UNITED STATES PATENT AND TRADEMARK OFFICE

Office Action Summary	Application No. 10/615,071	Applicant(s) RETTIG, DIRK J.	
	Examiner Vinh T. Luong	Art Unit 3682

1. The amendment filed on June 24, 2005 has been entered.
2. The drawings were received on June 24, 2005. These drawings are unaccepted by the Draftsperson because the drawings do not comply with 37 CFR 1.84 or 1.152. See attached Form PTO-948. In addition, these drawings are unaccepted by the Examiner, *inter alia*, because:

FIG. 5 (EXTENDED POSITION)

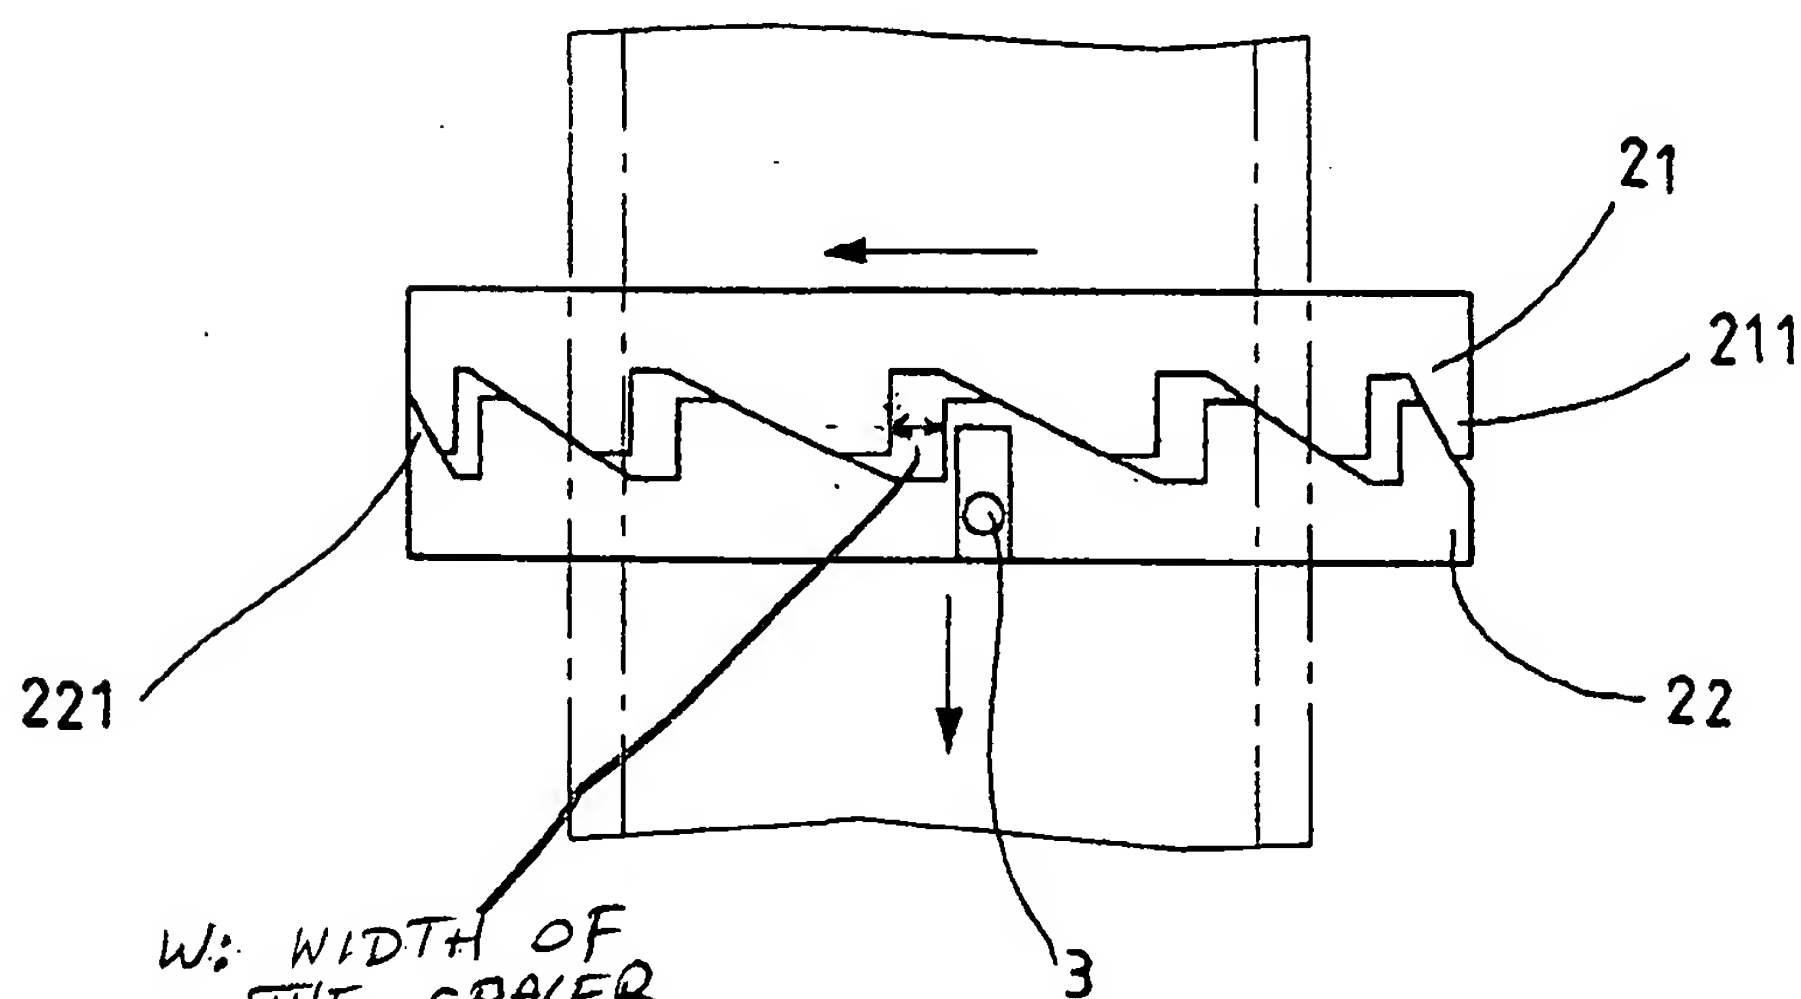
wherein rotation of the lower member 22 relative to the upper member 21 causes variable adjustment of a selected width (W, see Fig. 5 of Att.) of the spacer 21, 22, and wherein the one or more of the plurality of locking members 221 of the lower member selectively interlocks with one or more of the plurality of the locking members 211 of the upper member 21 so as to secure the spacer 21, 22 at the selected width (W, see Fig. 5 of Att.).

W: WIDTH OF
THE SPACER
IN THE EXTENDED
POSITION
